OFFICE OF NUCLEAR REACTOR REGULATION
REQUEST FOR ADDITIONAL INFORMATION
REGARDING THE RENEWAL OF
THE ARMED FORCES RADIOBIOLOGY RESEARCH INSTITUTE
TRIGA REACTOR FACILITY
LICENSE NO. R-84; DOCKET NO. 50-170

The U.S. Nuclear Regulatory Commission (NRC) is continuing its review of the Armed Forces Radiobiology Research Institute (AFRRI) license renewal application dated June 24, 2004 (a redacted version of the safety analysis report (SAR) is available on the NRC's public Web site at www.nrc.gov under Agencywide Documents Access and Management System (ADAMS) Accession No. ML041800067), as supplemented. The NRC staff's review used the guidance in NUREG-1537, Part 1, "Guidelines for Preparing and Reviewing Applications for the Licensing of Non-Power Reactors: Format and Content," and supporting information from the American National Standards Institute/American Nuclear Society (ANSI/ANS)-15.1-2007, "The Development of Technical Specifications for Research Reactors." During our review, questions have arisen, for which additional information and clarification is needed. This request for additional information (RAI) identifies the additional information needed to continue our review. Many o

AFRRI TRIGA MARK-F REACTOR
Conductivity as a Function of Time
2011 to 2016 (226 weeks)

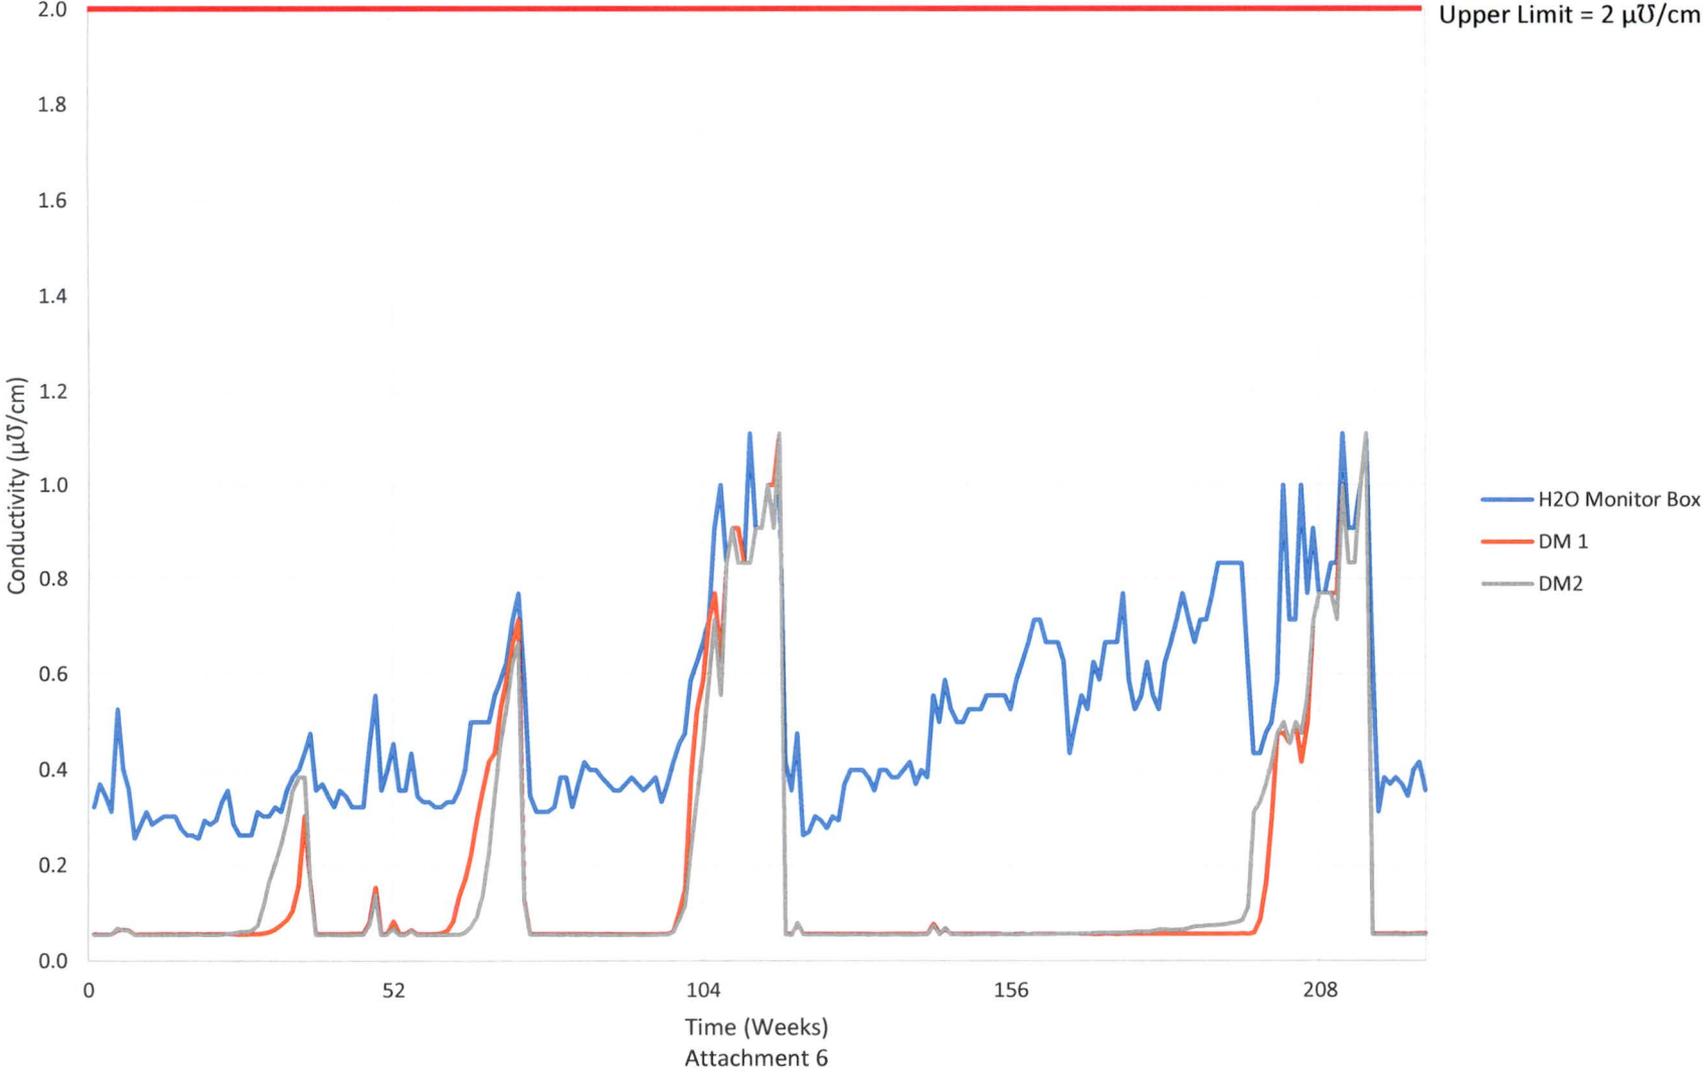
- B. The basis for the proposed TS 3.3 pool temperature limit discusses the protection of the water purification resins. Given that the thermal hydraulic analysis was based on the assumption of a maximum pool temperature of 60 degrees C, and given that reactor operation at temperatures greater than 60 degrees C would be unanalyzed, provide a revision to proposed TS 3.3 that specifies 60 degrees C as the maximum temperature permitted. Provide an appropriate basis for TS 3.3 that considers the results of the thermal hydraulic analysis. (See also RAI 31.D.)

The AFRRR TRIGA core is comprised of stainless steel clad fuel. Corrosion is generally not an issue with SS clad fuel. Furthermore, corrosion is not a flash process, so that monthly measurements will provide reasonable assurance that the resins are operating within normal parameters. Attachments 1-6 show conductivity vs time over the course of 5 years of normal operations. During the sample 5 year period of time, resins were changed out at intervals ranging from 36 to 99 weeks. During this time frame, the conductivity rarely exceeded 50% of the allowed value. Given the proven stability of the AFRRR system, sampling intervals of 90 days should be sufficient to protect the integrity of the system. The proposed sampling interval of monthly would appear to be excessive; however AFRRR will accept monthly

surveillance for conductivity measurements. No change to the proposed TS surveillance is warranted.
